APPLICATION NO.	FILING DATE	FIRST NAMED INVENTOR	ATTORNEY DOCKET NO.	CONFIRMATION NO.
10/664,982	09/17/2003	David Chong Sook Lim	112055-0040P1	4640
24267	7590	03/28/2006	EXAMINER	
CESARI AND MCKENNA, LLP 88 BLACK FALCON AVENUE BOSTON, MA 02210			ANDUJAR, LEONARDO	
			ART UNIT	PAPER NUMBER
			2826

Office Action Summary	Application No. 10/664,982	Applicant(s) LIM ET AL.	
	Examiner Leonardo Andújar	Art Unit 2826

DETAILED ACTION

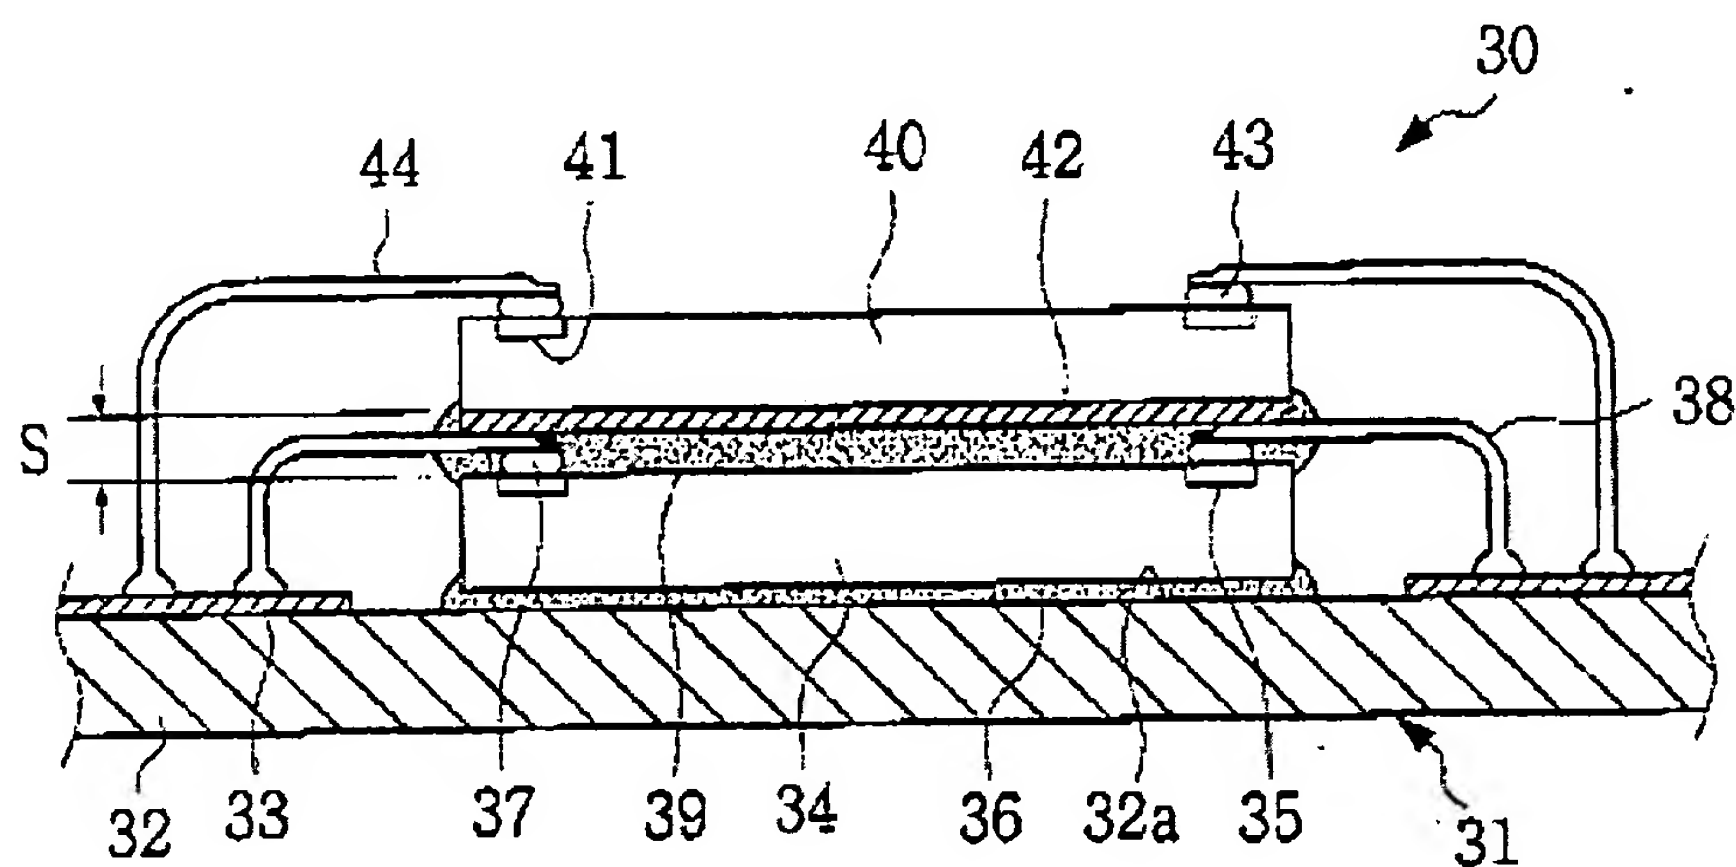
5. Regarding claim 1 Kang (e.g. fig. 3) shows a die containing package comprising:
a die 34 defining electrical die contacts 35, a substrate 31 defining first substrate

contacts (i.e. the contact/pad areas defined by 33/38), flattened electrical conductive balls 37 attached to the die contacts and making electrical connection thereto, electrical conductive runs 33 on the substrate 12 connecting the first substrate contacts to second substrate contacts (i.e. the contact/pad areas defined by 33/44), electrically conductive wires 38 with first ends making electrical connections to the first substrate contacts, wherein the wires are formed to run substantially parallel to the surface of the die and wherein the other ends are horizontally attached to the flattened balls.

FIG. 9

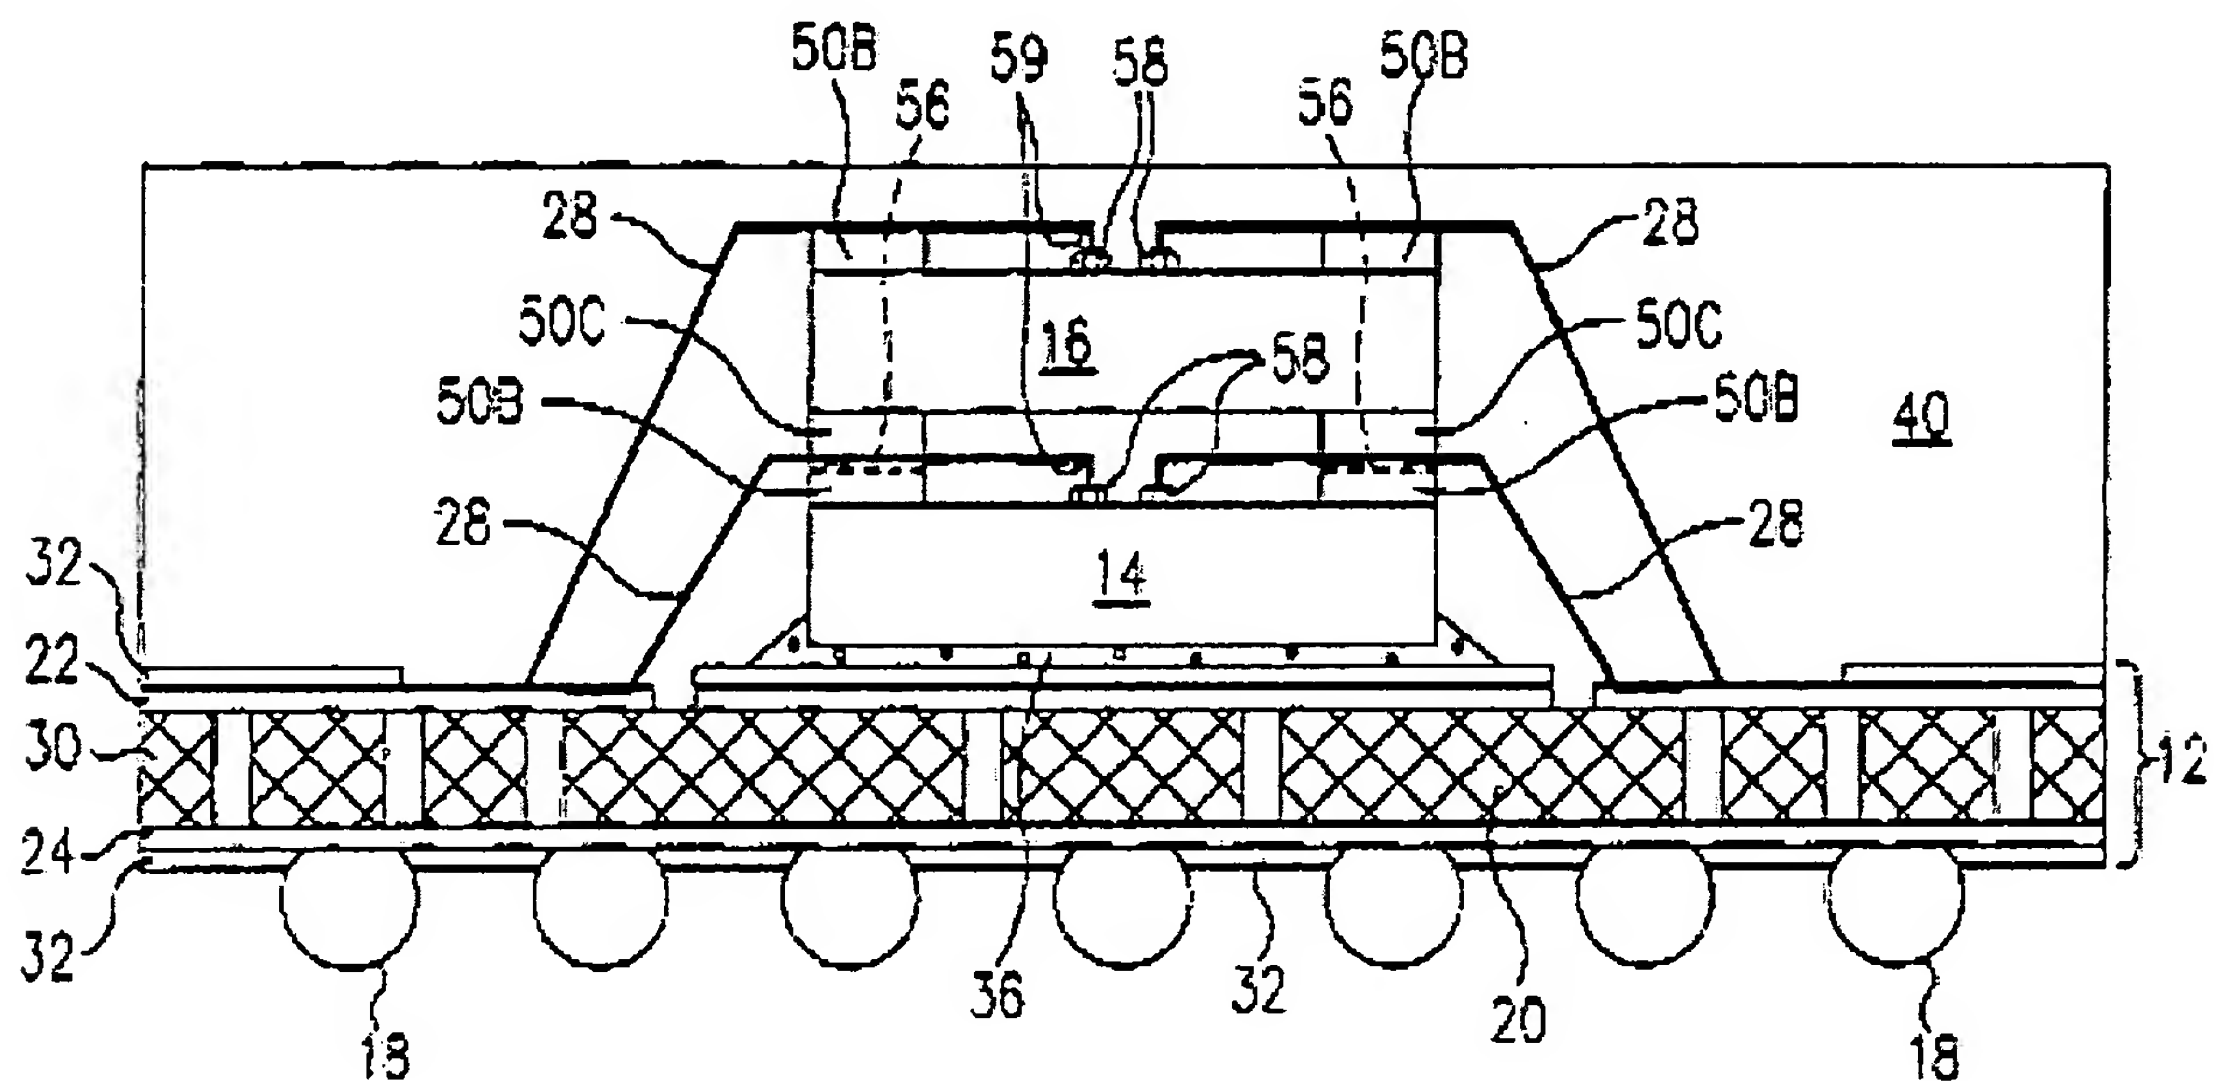
12. Regarding claim 1 Shim (e.g. fig. 9) shows a die containing package comprising: a die 14 defining electrical die contacts, a substrate defining first substrate contacts, flattened electrical conductive balls 58 attached to the die contacts and making electrical connections thereto, electrical conductive runs 22/24 on the substrate 12 connecting the first substrate contacts (i.e. the electrical contacts formed by the runs and the wires 28) to second substrate contacts 18, electrically conductive wires 28 with a first ends making electrical connection to the first substrate contacts, and wherein the

other ends are arranged making electrical connections to the flattened electrical conductive balls attached to the die contacts.

Shim does not teach that other ends are horizontally attached to the flattened ball. Nevertheless, Kang (e.g. fig. 3) shows electrically conductive wires 38 that run substantially parallel to the surface of the die and have ends that are horizontally attached to flattened balls 37. According to Kang, this type of connection minimizes a space between the first chip and a second chip, thereby reducing the total height of the semiconductor stack (abstract). It would have been obvious to one of ordinary skill in the art at the time the invention was made to horizontally attach the other ends of the wires disclosed by Shim to the flattened balls in accordance to Kang's invention to minimize the space between the first and the second chip, thereby reducing the total height of the semiconductor stack.
